GREAT LAKES INDIAN FISH AND WILDLIFE COMMISSION

August 11, 2015

Re: Comments on PolyMet mine site contaminant northward flowpath and groundwater model calibration.

Large Figure 29
 MINE SITE GROUNDWATER
 FLOW PATHS - BEDROCK
 NorthMet Project
 Poly Met Mining Inc.
 Hoyt Lakes, MN

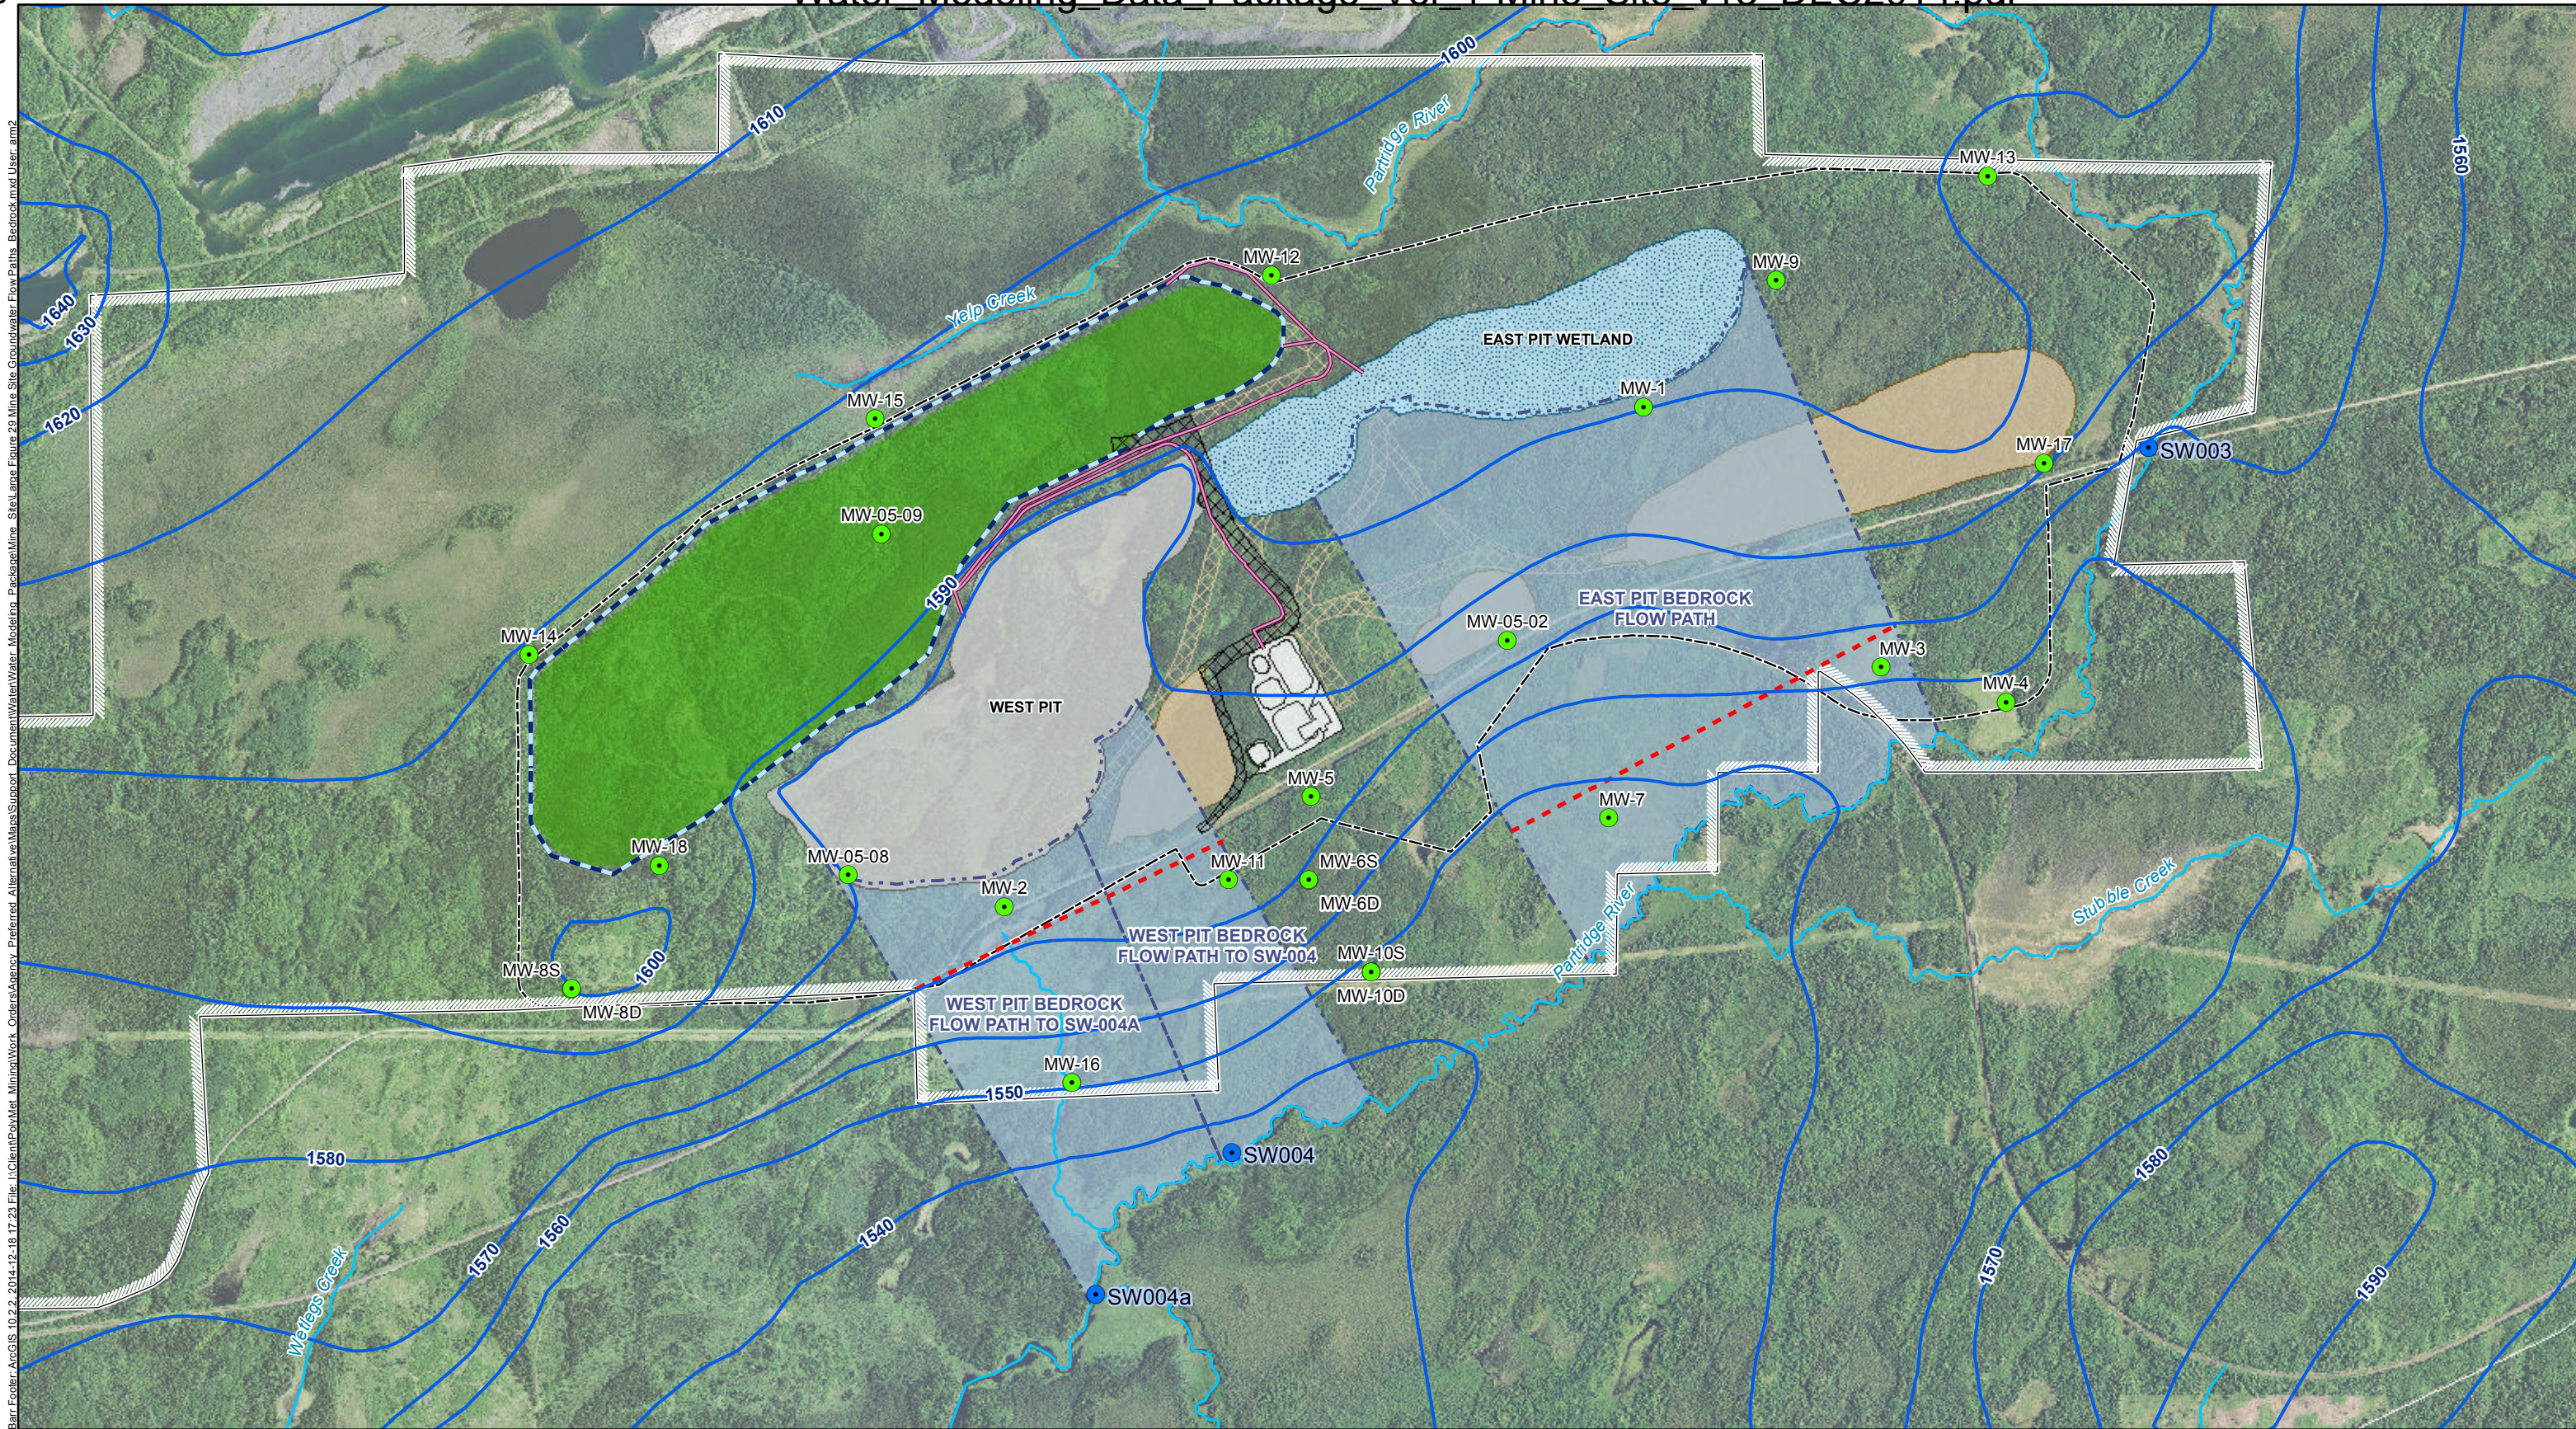
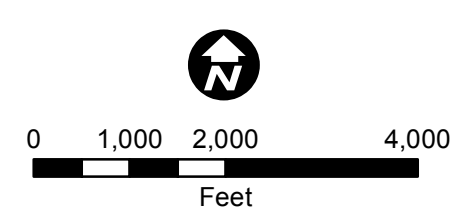
Large Figures 28 and 29 of the Water Modeling Data Package Vol_1-Mine_Site_v13_DEC2014, .pdf pages 510 & 511 (contaminant flowpaths)

Those predicted contours were used in the Water Modeling Data Package to define flow paths (Large Figure 29 of the Water Modeling Data Package Vol_1-Mine_Site_v13_DEC2014). As stated on page 75 of the Water Modeling Data Package v13 (.pdf page 82):

Water Levels in Peter-Mitchel Area003-east pit

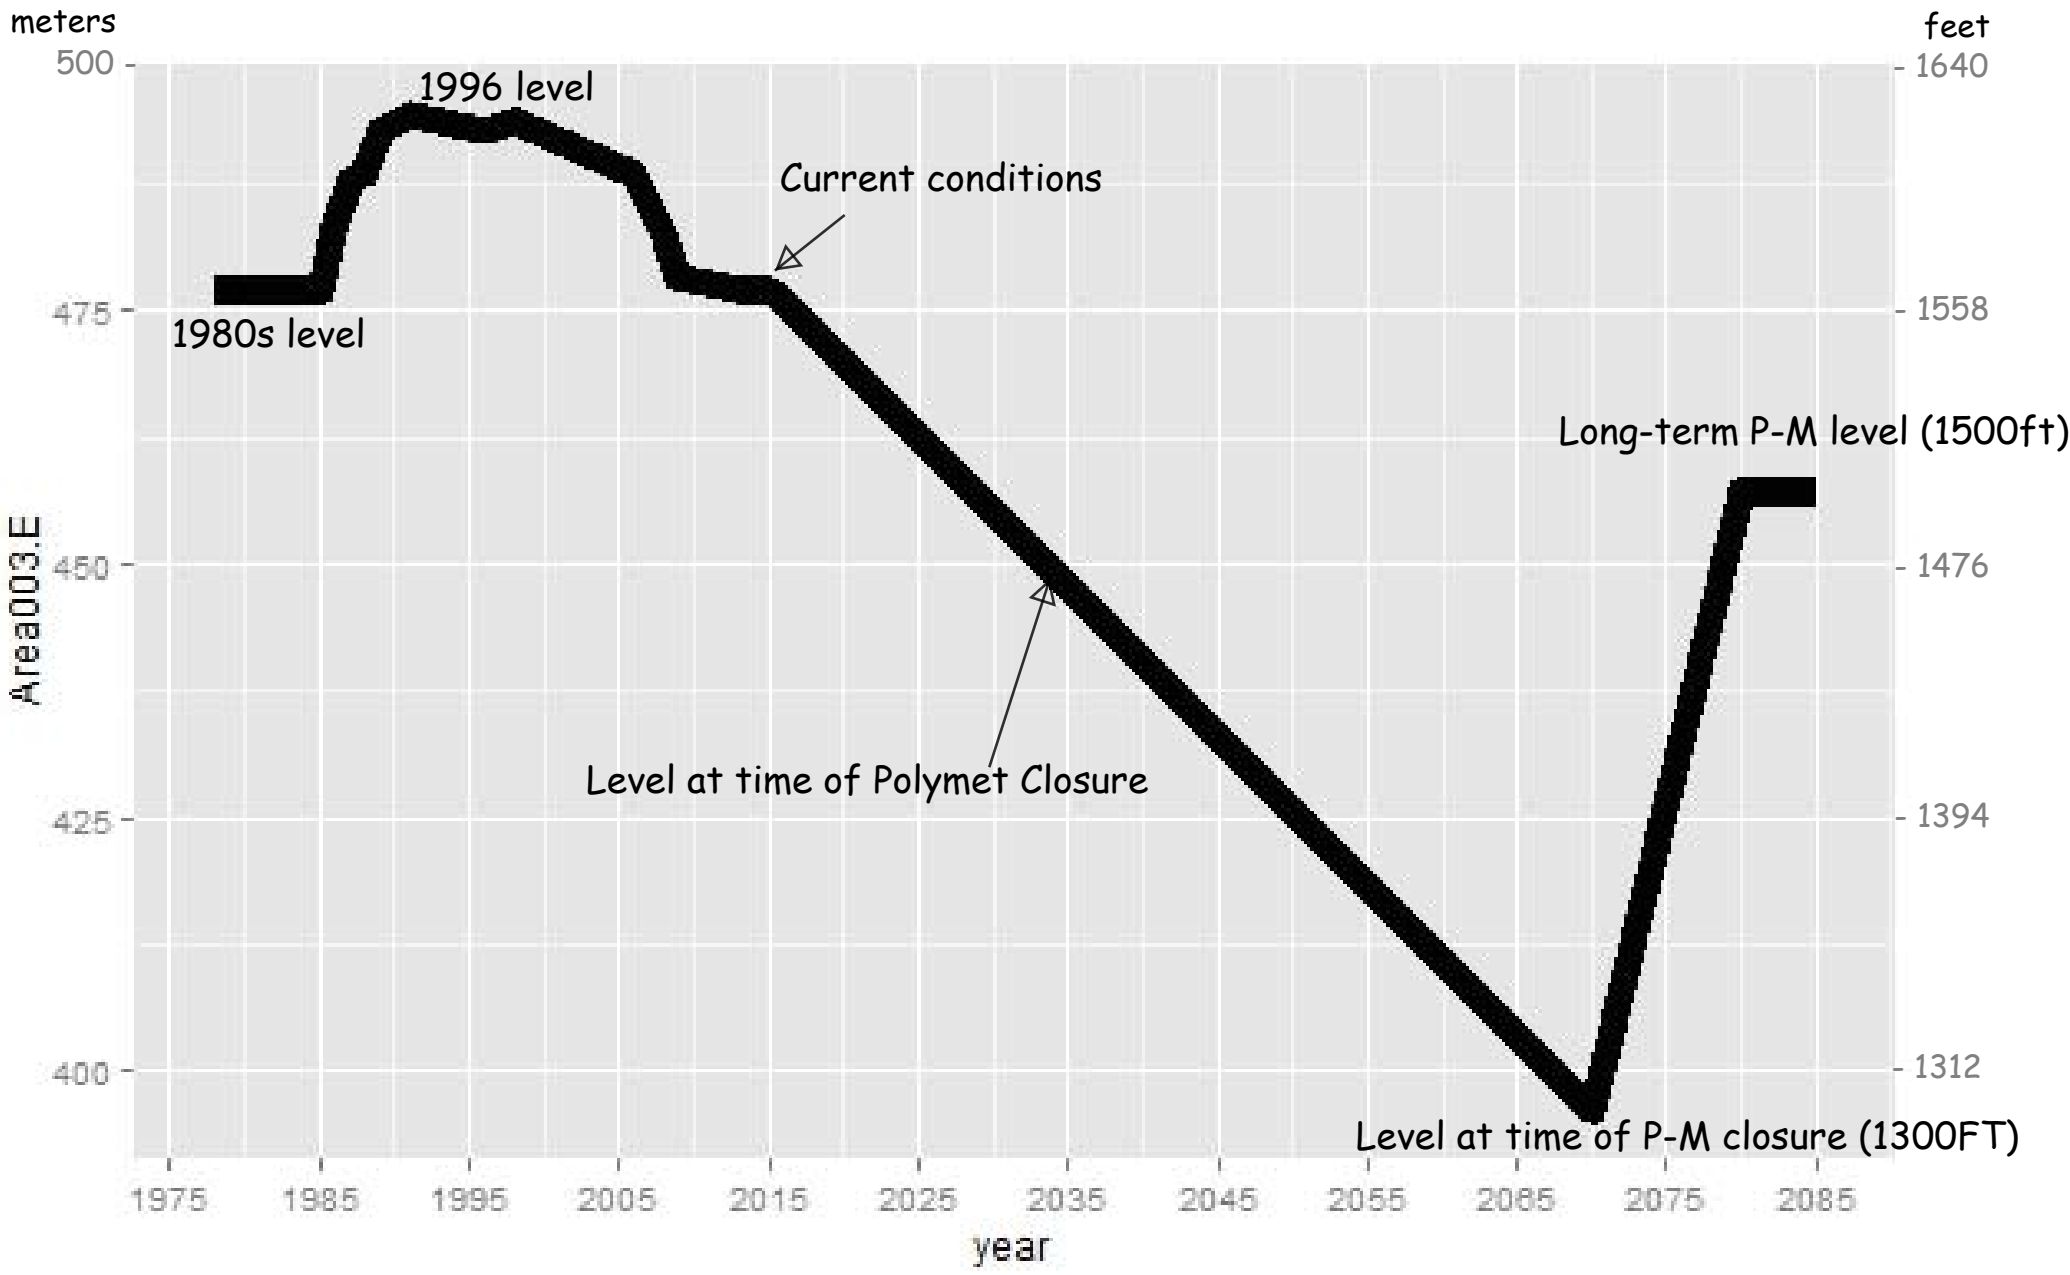
Water levels in the P-M Area003-East pit increased from an elevation of less than 478 meters in 1979 to 488 meters in the fall of 1987. During most of that period the Area003-East pit was empty, i.e. less than 478 meters elevation. In contrast the 1996 water level used for the Area003-East pit was 492.6 meters elevation. The P-M pit water levels were not vaguely "variable" as stated in the draft memo on calibration, but rather consistently well below the levels used in the Barr MODFLOW modeling. The 1996 water level used for the P-M pits as a boundary condition in the modeling was abnormally high. Such high levels did not occur in the 1980s, do not occur now and will not occur at closure.

Figure 1
Ultimate Topography of the PMP
(without Mitigation)
Peter Mitchell Pit Mitigation Plan
North Shore Mining
Babbitt, Minnesota

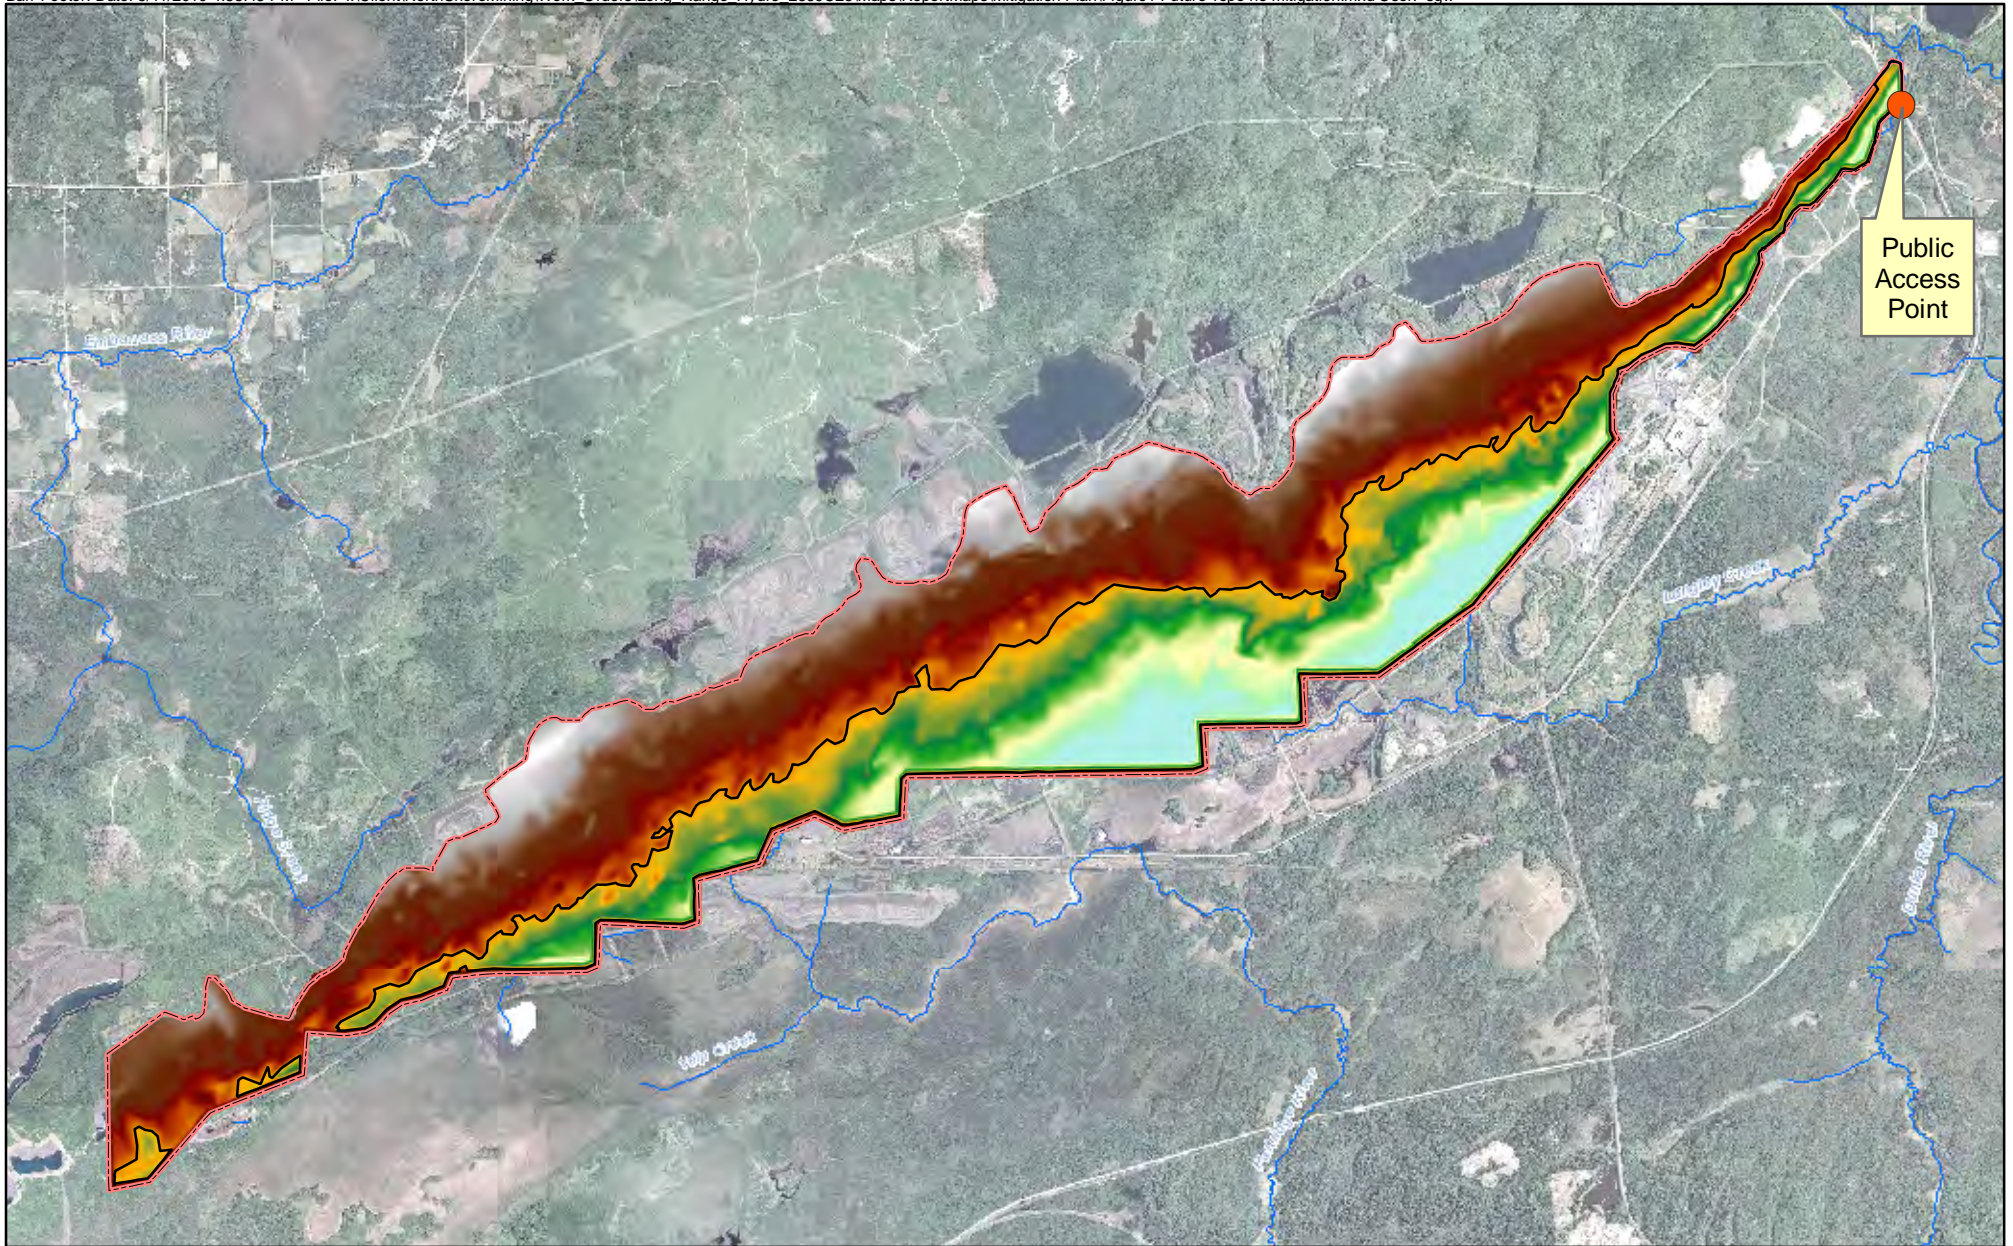
The project mine site MODFLOW model distributed to cooperating agencies on January 5, 2015 was used by the applicant to predict that contaminants would flow from the mine site at closure to the south and south-east (for example: Large Figures 28 & 29 of the WMDPv13, attached as Figures 3 and 4). In those project model runs of closure conditions, the water levels in the P-M taconite pits were assumed to remain at the level found in 1996. At closure the P-M pits will not be at 1996 levels but over 300 feet lower. In fact those 1996 levels were atypical; they did not occur in the 1980s, do not occur now and will not occur at closure. A plot of water levels in the Area003-East P-M pit, the pit closest to the PolyMet east pit, shows how atypical the mid-1990s water levels were (attached as Figure 5). In the project predictive models of closure conditions, the adjacent taconite pits to the PolyMet project site were set to have a 1996 water elevation of 1616 feet or 493 meters. However, the P-M taconite pit water levels expected at P-M pit closure are 1300 feet or 396 meters. After reflooding of the P-M pits, the water levels in those pits will be maintained by an outfall in the north-east at 1500 feet or 457 meters (see figure from the Northshore Watershed Mitigation Plan of 2011, attached as Figure 6).

Figure from the Northshore Watershed Mitigation Plan of 2011. - A map of the Peter-Mitchel pit final lake water elevation from the Feb. 11, 2011 report titled "Watershed Mitigation Plan" (MDNR 2011s.pdf) which contains the May 2010 BARR Engineering document titled: "Peter Mitchell Pit Concept Mitigation Plan". That plan identifies the final status of the P-M pits as being connected into a long east-west pit that will be allowed to fill to a water elevation of 1500 ft (457 meters). The recreational lake formed by this filling is scheduled to passively discharge to a tributary of the Dunka River in the north-east. While the ultimate water level in the reflooded P-M pits is expected to be 1500 feet, in the interim, the taconite pit bottoms continue to be deepened to an elevation of approximately 1300 ft (396 meters). In 2011 the bottoms of the P-M pits ranged down to an elevation of 1394 feet (425 meters).
